Bedroom 1's bathroom · design review F-05 · accept the route (A) or a private bathroom (B)? · Taif / Palm House · A ADOPTED · B NOT ADOPTED: young children's room (owner, V9.0)

OPTION A ADOPTED by the owner (2 Nov 2026): no private bathroom; the wet areas stay grouped in the two clusters; night lights along the route. 2 Nov 2026, after the stair flip (option B, F-b) · bedroom 1 is the north-east room over the maid wing, 15.75 m² on axes, 13.9 m² clear, one room without a bath · nothing in the design files changes until the owner decides · all sizes assumed

bedroom 1 · A · 1 m = 0.95 cm · north up · brown dotted = the ground floor below

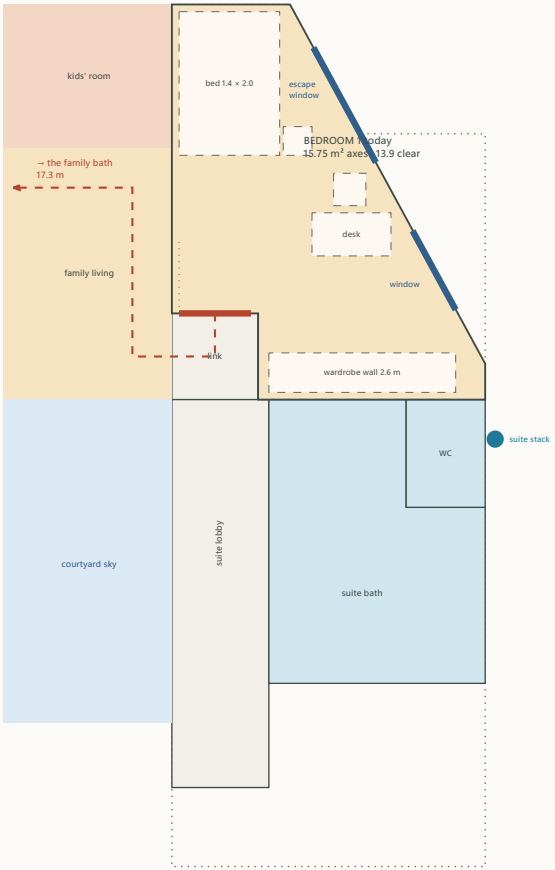
Option A · accept the route

- **The walk, measured after Part 1** (the stair flipped, the family bath enlarged northwards; its door stays at x 4.25, y 9.3–10.3): bedroom 1's door → the family link → the family living, behind the sofa → the gallery's north part, past the stair arrival → the gallery → the bath's door: **17.3 m** (the same as before the flip: the bath grew, its door did not move). Five spaces, two of them lived in (the living, the gallery).

- **Who shares the family bath:** bedroom 1 (17.3 m), bedroom 2 (2.7 m), the kids' room and the family living (a bedroom later); bedroom 3 and the suite have their own. Since F-b it has **two compartments** (a WC by the shaft and the shower + double basin), so two children at once.

- **Comfort:** a child or a guest in bedroom 1 crosses the **family living** at night and in the morning, in sight of whoever is there; 17 m is the longest bathroom walk in the house (the suite's is 0, bedroom 3's 2.7, bedroom 2's 2.7).

- **Cost:** nothing; the plumbing stays as it is.

bedroom 1 · B2 · 1 m = 0.95 cm · north up · brown dotted = the ground floor below

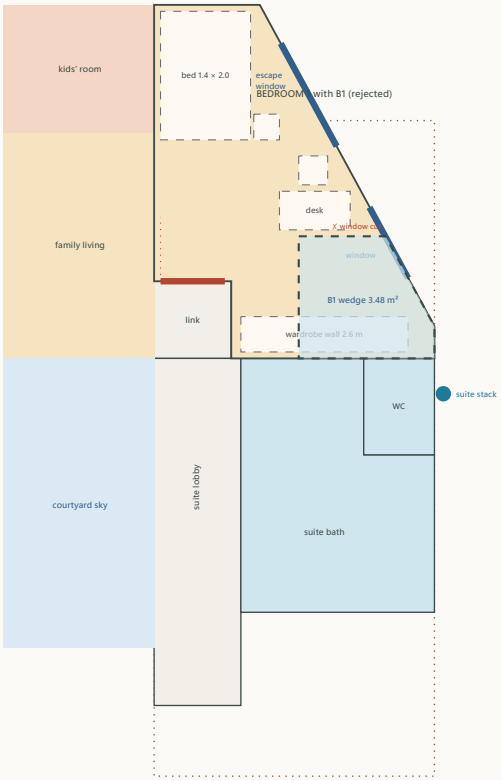
- **B2 (the best, drawn):** a bath along bedroom 1's **south wall**, x 10.6–13.311, y 5.0–6.5, its east end following the cut wall: **3.79 m² on axes, 2.49 × 1.3 clear less the slant ≈ 3.0 m²**: a walk-in shower 0.9 × 1.2 at the east end (its corner 0.02 m west of the cut wall), the WC in the middle facing north, the basin on the west wall, a **sliding 1.0 m door** from the room (no swing), a **small window on the cut wall** (y 5.35–5.85, sill +1.60, obscured). It is **next to the master suite's wet stack**: the pipes run 2.5 m east in the bath's own floor zone to the suite's stack outside the east wall (y 7.05), **over the GF maid room only** (the kitchen and its hood zone start at y 7.0; nothing over the master bedroom).

- **Bedroom 1 with B2: 11.96 m² on axes, ≈ 10.3 m² clear** (was 15.75 / 13.9): the bed 1.4 × 2.0 stays on the west wall with its bedside table, the desk and chair under the escape window, the wardrobe wall (2.6 m) becomes **two wardrobes, 1.3 m on the bath's wall and 0.9 m on the west wall** (2.2 m in all); the door's swing stays clear; the **escape window stays the room's** (the fire study unchanged); the second window (y 4.15–5.25) lights the desk. Still a full bedroom (a 1.4 bed, a desk, 2.2 m of wardrobe), no longer a two-bed room.

- **Drain:** the shower, the WC and the basin to one branch running east along the bath's south side to the **suite's stack** outside the east wall (y 7.05), 2.5 m; the branch crosses the room's south wall line at x 13.311 and turns south outside the wall for 0.6 m (or a second stack beside the suite's; the MEP engineer). **Over the GF maid room only**: not over the kitchen (y ≥ 7.0), its hood zone (the east wall y 10.2–11.2) or the master bedroom (x 8.95–13.311, y 11.9–19.25).

- **Structure (`studies/structure.typ`):** the maid wing's first-floor bay is a **solid 0.20 slab** spanning east–west 4.36 m to the cut wall; a 0.15 depressed zone cannot be cut from 0.20. Two ways, the engineer's choice: **(i)** cast the bay 0.35 thick under the bath with its top depressed 0.15 (as the suite bath, X10), or **(ii)** keep the slab and run the pipes **below** it in the maid room's ceiling void (the maid room gets a gypsum ceiling anyway; 3.1 m clear left) with a wall-hung WC and a shower tray raised ≈ 0.10. The bath's walls are light partitions on the slab (no beam; B6 at y 6.5 is the room's south wall beam, untouched).

- **Windows:** the bath's small window on the cut wall faces the lane side (obscured glass, a vent); the room keeps both its windows. **Ventilation:** the window plus an extract fan to the roof riser is not available here: an extract through the cut wall (a small louvre) or a duct in the ceiling void to the east wall.

- **Neighbours:** the maid room below hears the bath (pipes in a ceiling void: wrap them); the suite's WC closet shares the stack; the family link and the suite lobby are untouched; the family bath keeps serving bedroom 2, the kids' room and the living.

Recommendation: B2, if bedroom 1 is to be a guest room or an older child's room; otherwise A

- The route is the longest in the house and crosses the living: that is the real cost of A, and the only one. B2 answers it for ≈ 3 m² of the room and one more wet room; it is the only tidy position (B1 is a wedge that cuts a window, B3 takes the escape window). **Conditions for B2:** the engineer chooses the slab detail (i) or (ii); the MEP engineer the stack connection and the vent; the wardrobe split accepted.
- **If A:** keep the family bath as F-b (two compartments) and note in the house rules that bedroom 1's user has the family bath; nothing else to do.

bedroom 1 · B1 · 1 m = 0.95 cm · north up · brown dotted = the ground floor below

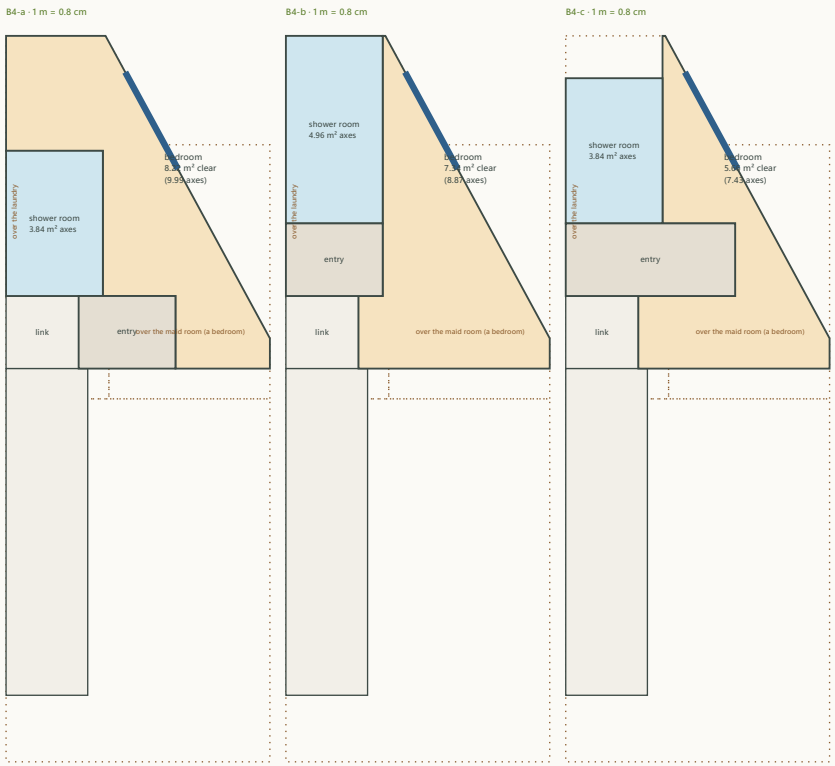
- **B1 (the south-east wedge, dashed on page 2):** x 11.2–13.311 on the cut wall, 3.48 m²: a wedge, its north wall cuts the second window (y 4.15–5.25) and leaves 0.8 m of the wardrobe wall: worse than B2 for the same plumbing. **B3 (the north-east corner):** the north-east corner (x 10.6–12.0, y 1.0–2.9) holds the room's **escape window** and the bed's head wall: a bath there moves the escape window and the bed; rejected without drawing.
